SERVICE BULLETIN #8 – Install sleeves in flipper bushes

16th April 2019 - REV 1.1

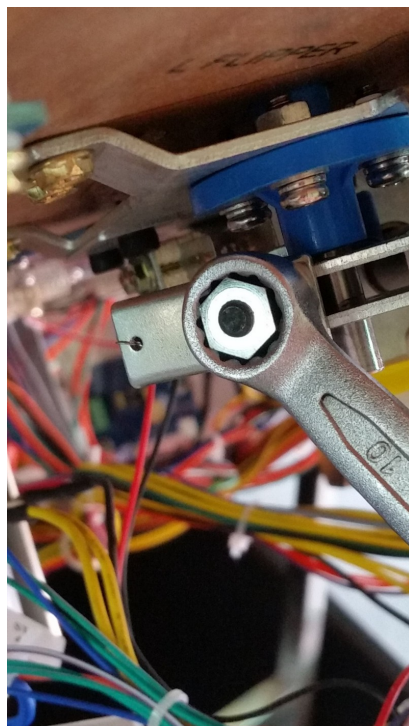
TAG. Sloppy or loose feeling flippers. Flipper bat sideways movement in the nylon bush seems excessive.

Remedy: While this has not caused any particular issues some customers have complained that the flipper “feel” is not right and they believe it is caused by the flipper shaft being a loose fit in the nylon bush. This modification installs stainless steel sleeves into the nylon bushes and makes the flipper shaft a machine fit in the bush.

(1) lift the playfield into the service position using the playfield prop. Using a 10mm spanner, loosen the retaining nuts for the flipper bats and take out both flipper bat assemblies.

(2) Push fit a stainless steel sleeve supplied into each blue nylon flipper bush from the top of the playfield, initially by hand. You should be able to easily push them in more than halfway. Take care as the ends are sharp!
